APPLICATION FOR PERMIT TO DRILL						1. WELL NAME and NUMBER CWU 1311-02	
2. TYPE OF WORK DRILL NEW WELL <input checked="" type="checkbox"/> REENTER P&A WELL <input type="checkbox"/> DEEPEN WELL <input type="checkbox"/>						3. FIELD OR WILDCAT NATURAL BUTTES

To: Assistant District Manager Minerals, Vernal District
From: Michael Coulthard, Petroleum Engineer
Subject: 2008 Plan of Development Chapita Wells Unit
Uintah County, Utah.

Application for Permit to Drill Statement of Basis

CWU #1311-2
SECTION 2, T9S, R22E, S.L.B.&M.
1811' FSL 2523' FWL

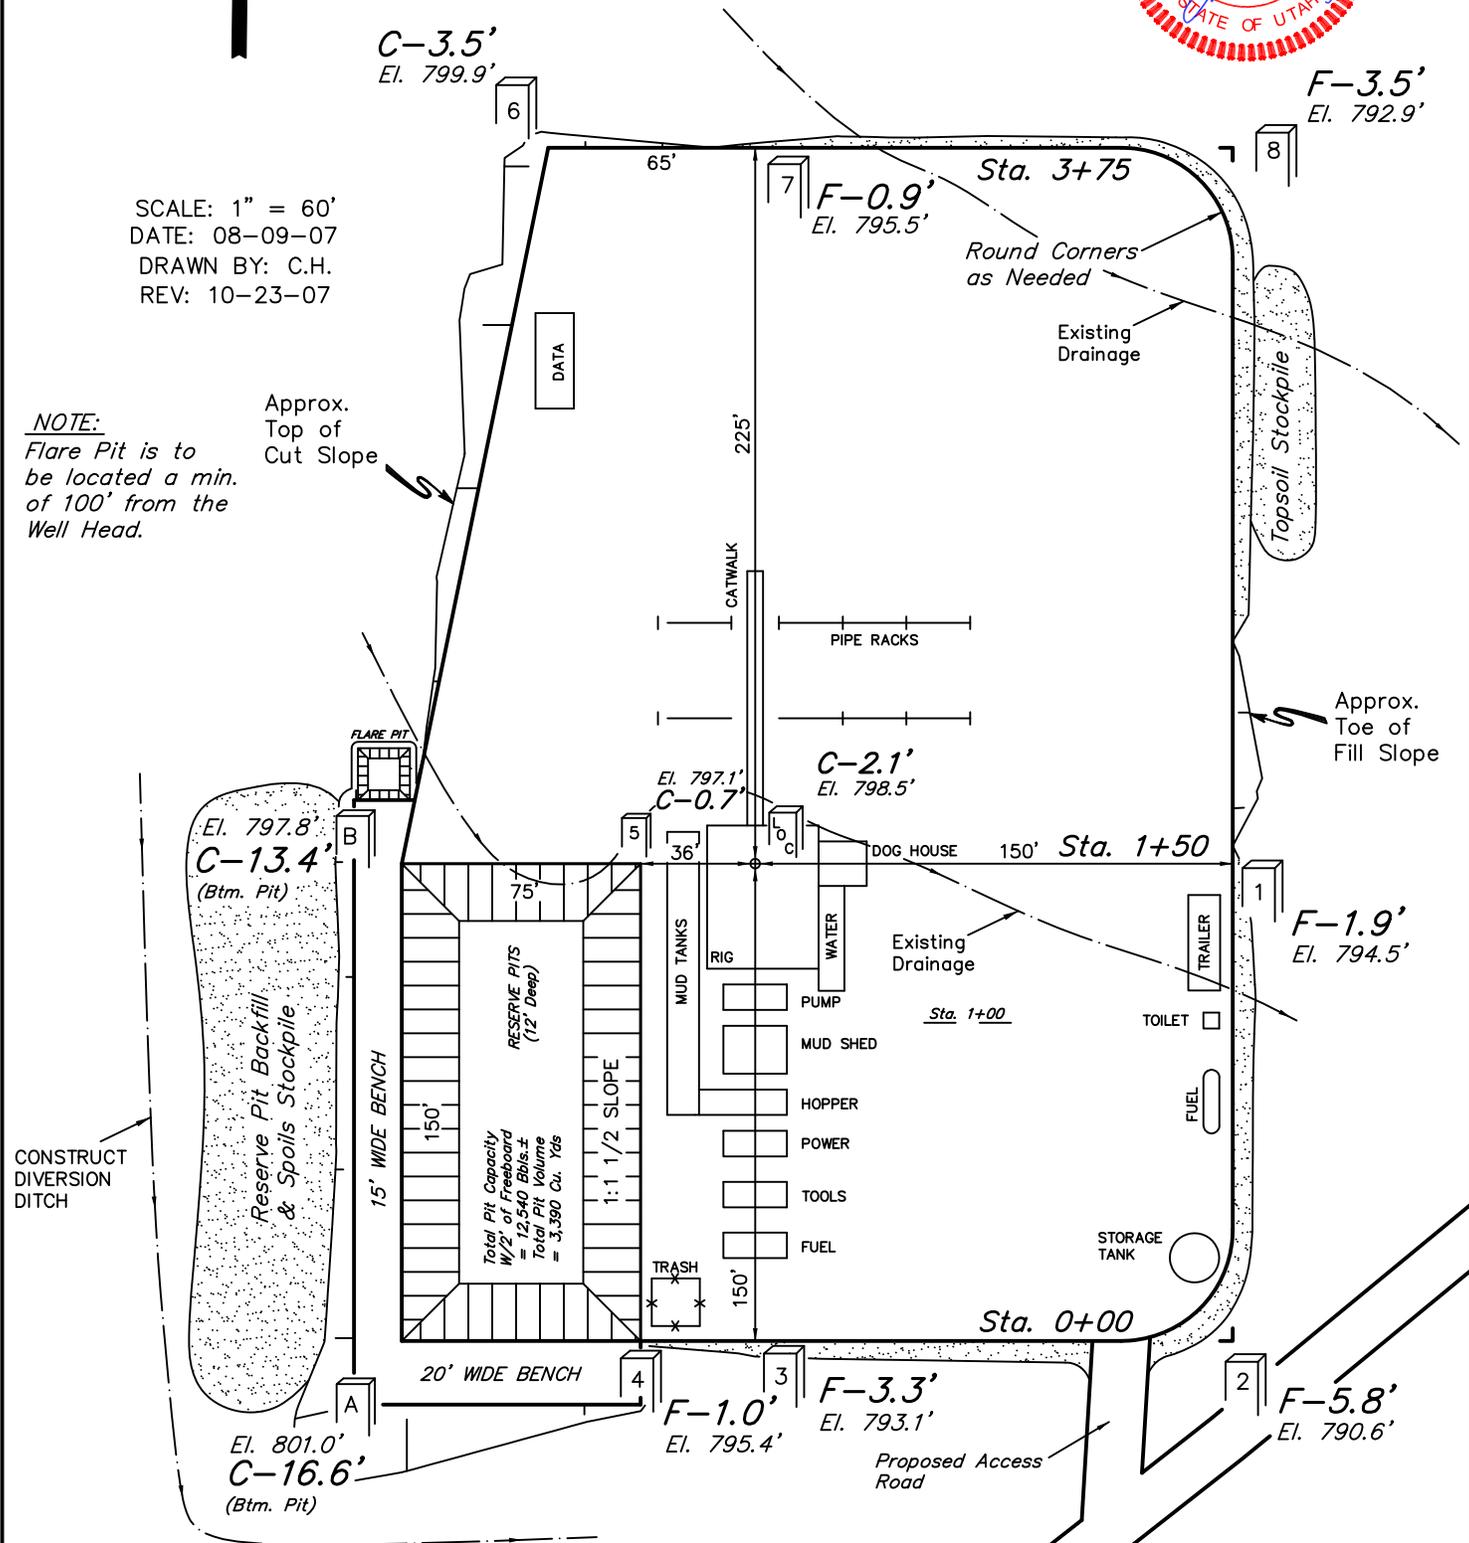
The proposed CWU 1311-02 gas well location is within a barren area dominated by high clay mounds. Two seasonal drainages intersect the location. Mounds in the center of the site will be leveled to form a majority of the pad. A drainage thru the northeast corner of the proposed pad needs to be diverted around the pad. A winding drainage thru the center needs to be contained and diverted. To complete this, spoils from the reserve pit will be placed in the drainage to contain any flow that occurs during drilling or while the reserve pit is open. A diversion will be connected to this fill taking any spillover flows to the east and north into an existing drainage. A more defined diversion will be constructed after the reserve pit is closed. Pad width between Pit Corner B and Location Corner 6 is planned to be narrowed because of a high clay mound that occupies that area. Additional rounding at Corner 6 is needed to avoid the difficult topography in that area.

With the noted modifications made, the location appears to be a suitable site for constructing and operating a well. Both the minerals and surface are owned by SITLA. Jim Davis representing SITLA. He participated in determining the noted changes and had no other concerns with the proposal.

Casing Schematic

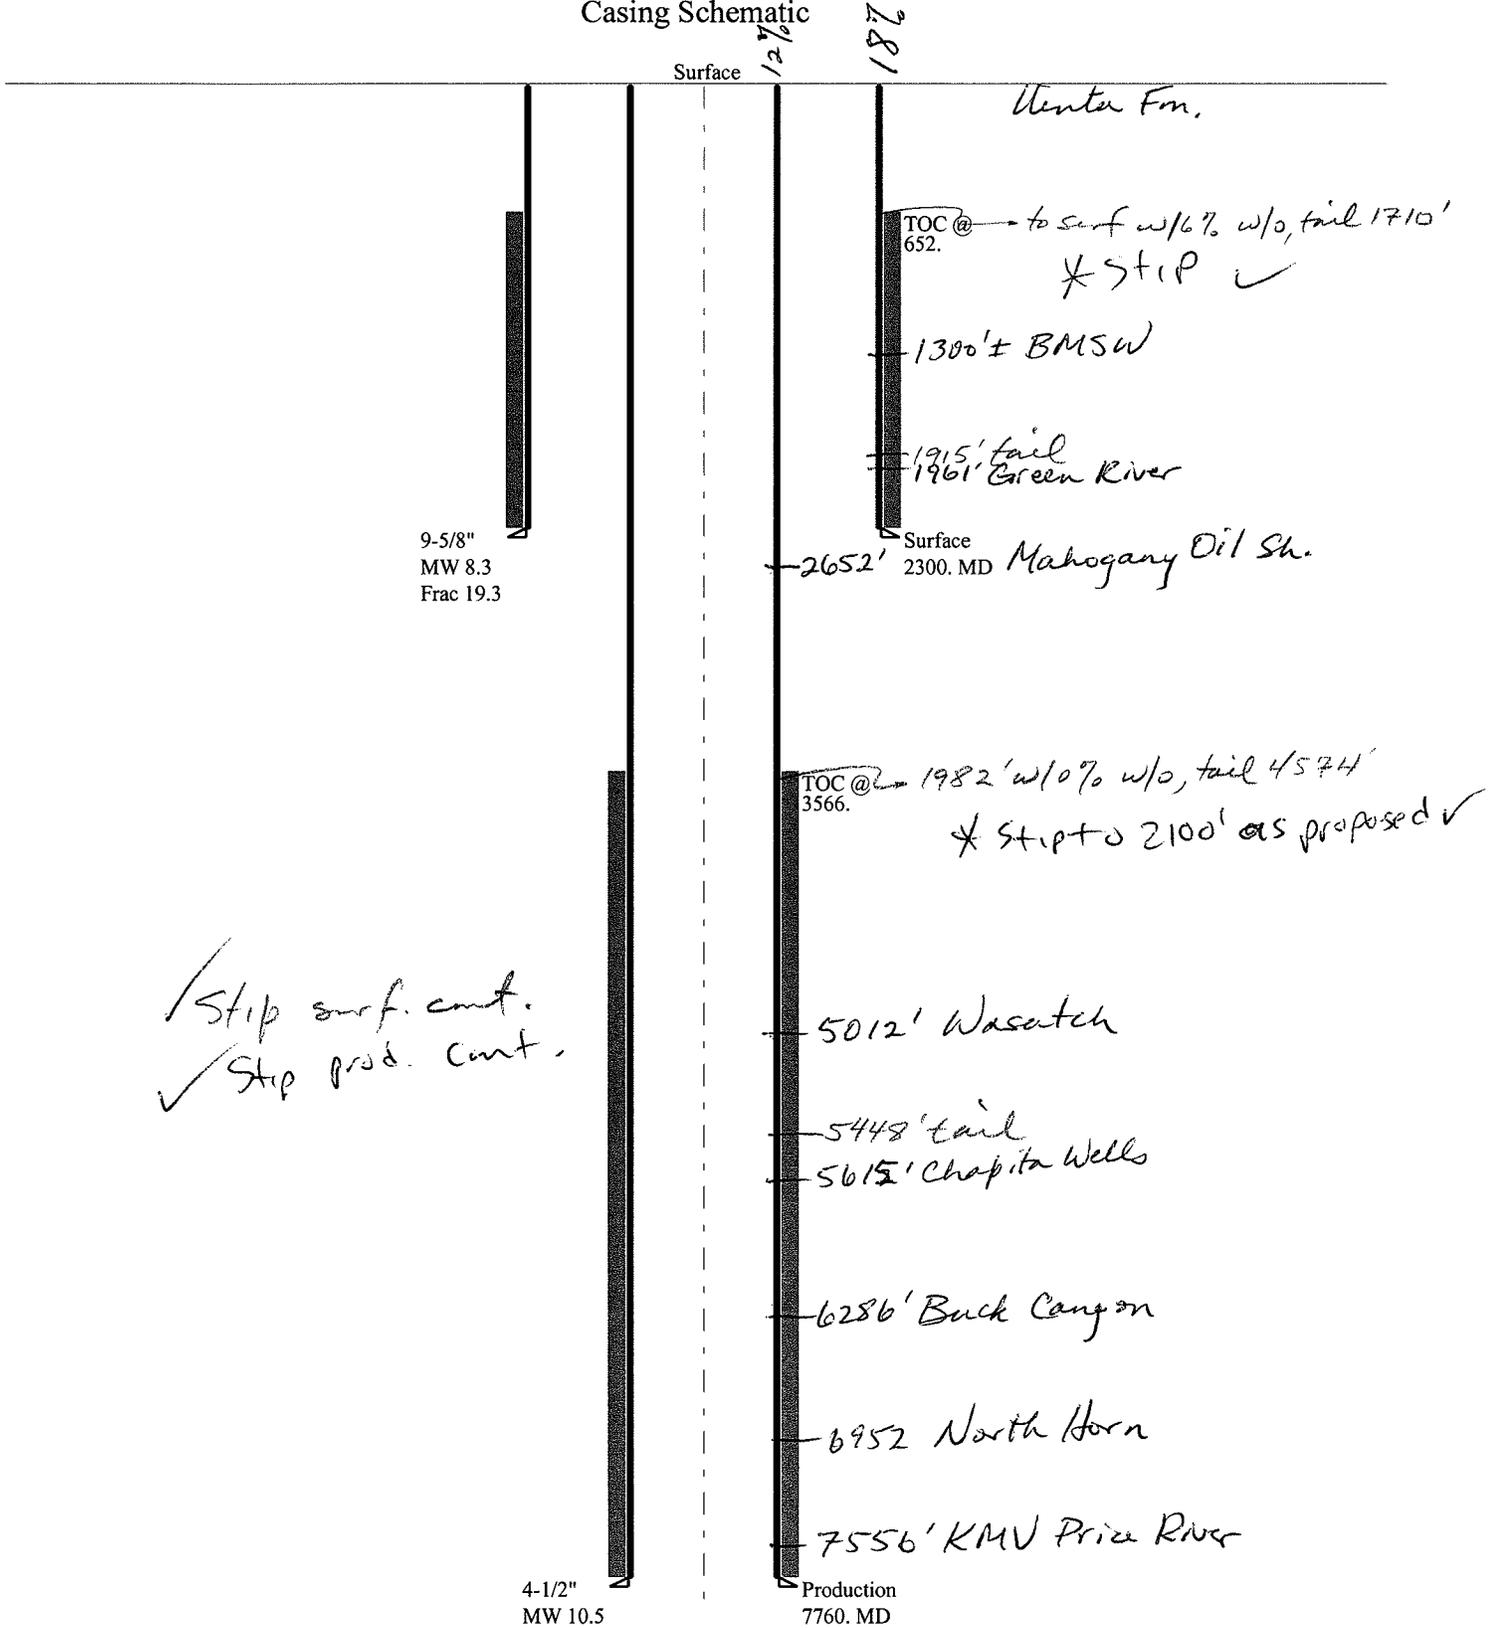
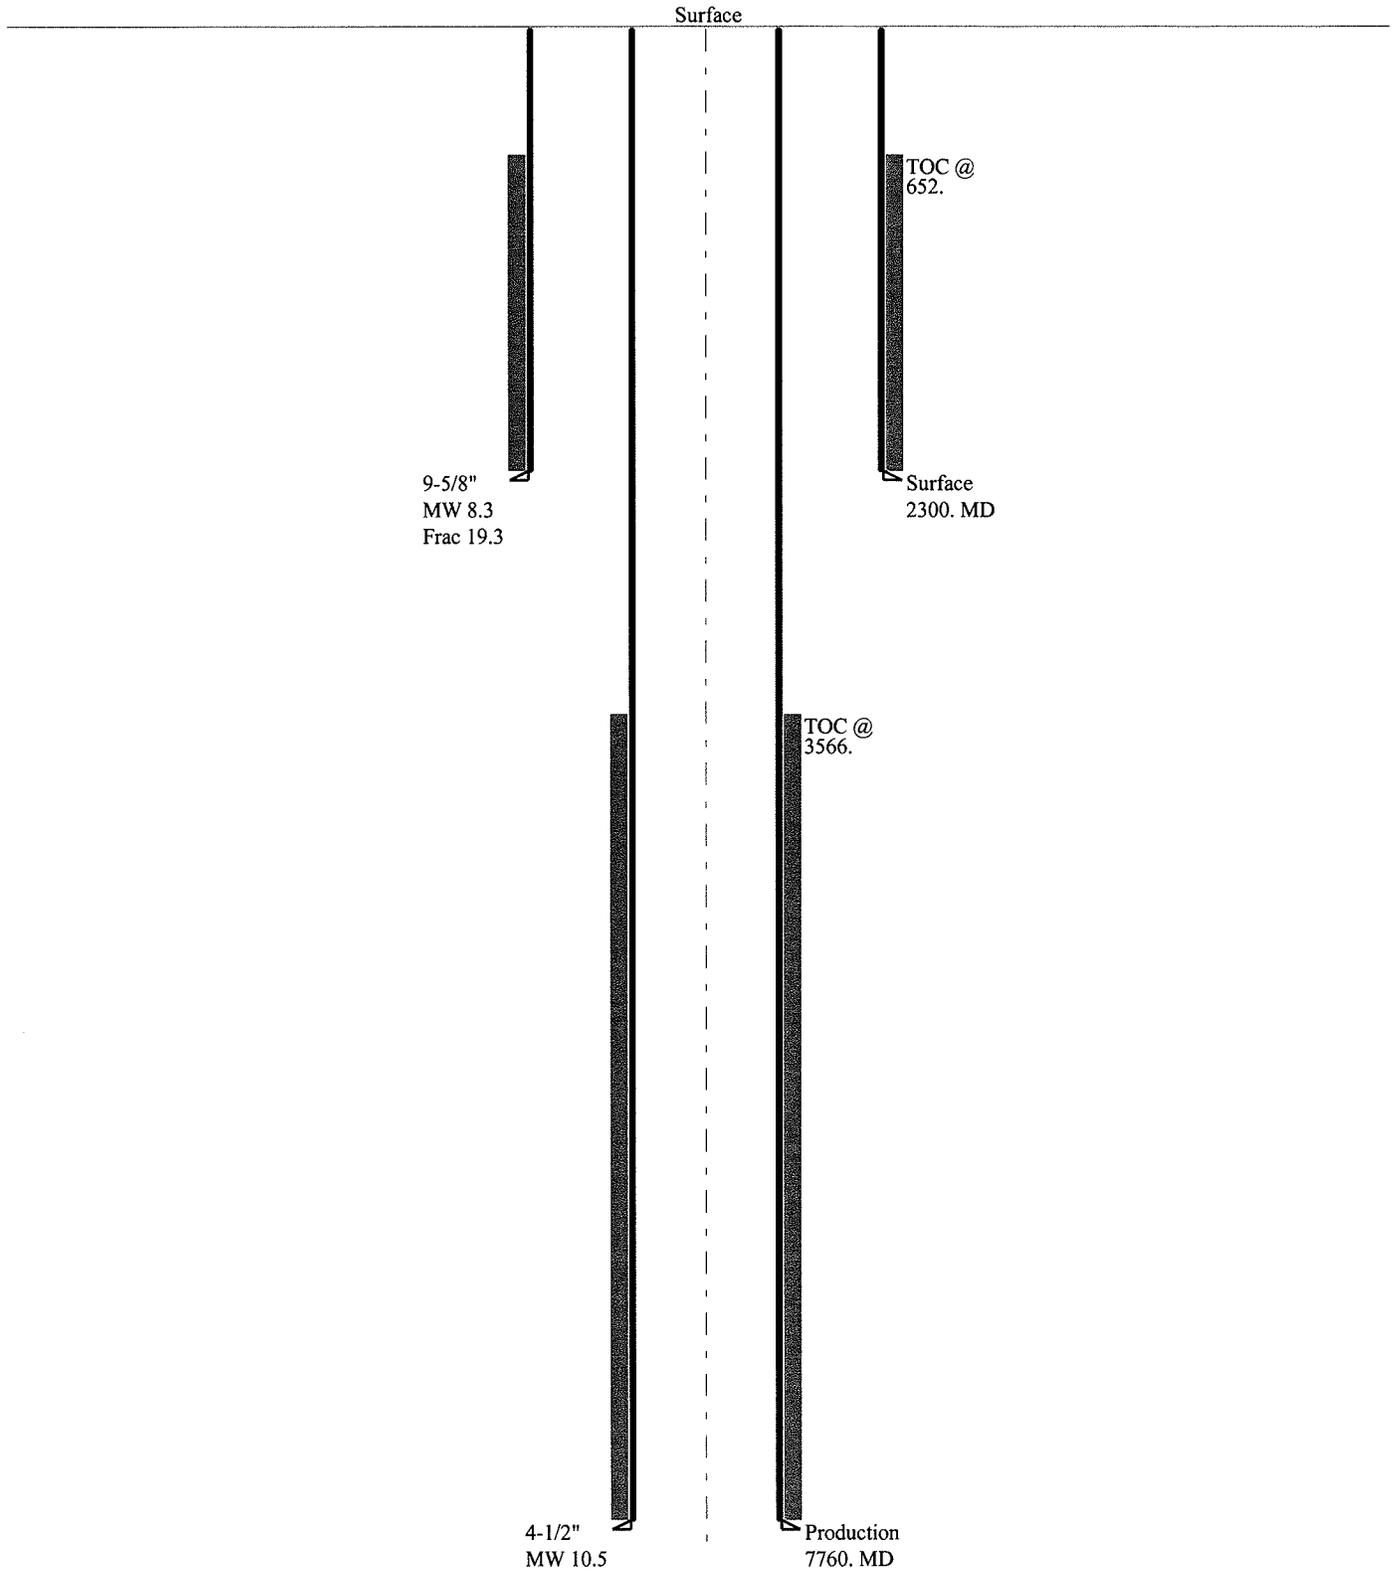
✓ Stip surf. cont.
✓ Stip prod. cont.

Cement volume for the 4 1/2" production string shall be determined from actual hole diameter in order to place cement from the pipe setting depth back to 2100' MD as indicated in the submitted drilling plan.
